ERRATA TO: D. Prutchi, "Passive-Detector Receiver Keeps You Informed, Entertained During Flights", Design Idea, *EDN*, 98-99, May 12, 2005.

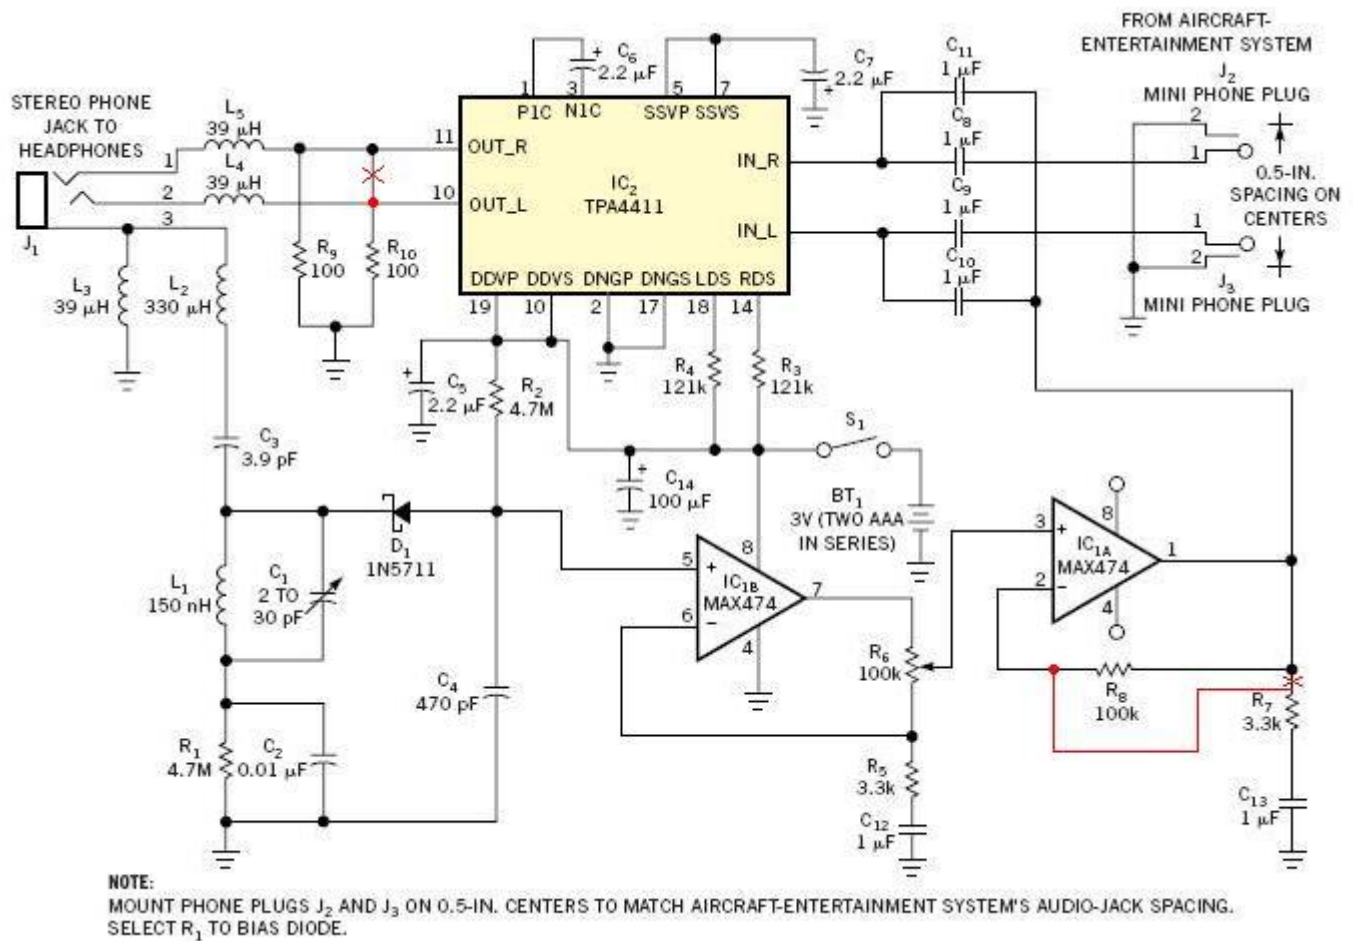
EDN's graphic artist had to redraw my OrCAD schematic from scratch to make it compatible with EDN's publishing software. Unfortunately, galley proofs are not sent out for review by the author before publishing, and this resulted in the introduction of the following mistakes in the schematic (corrected schematic courtesy of EE and pilot Brenor Brophy):

- 1) R7 should connect to pin 2 on IC1a not pin 1.
- 2) R10 should connect to pin 10 on IC2 not pin 11.
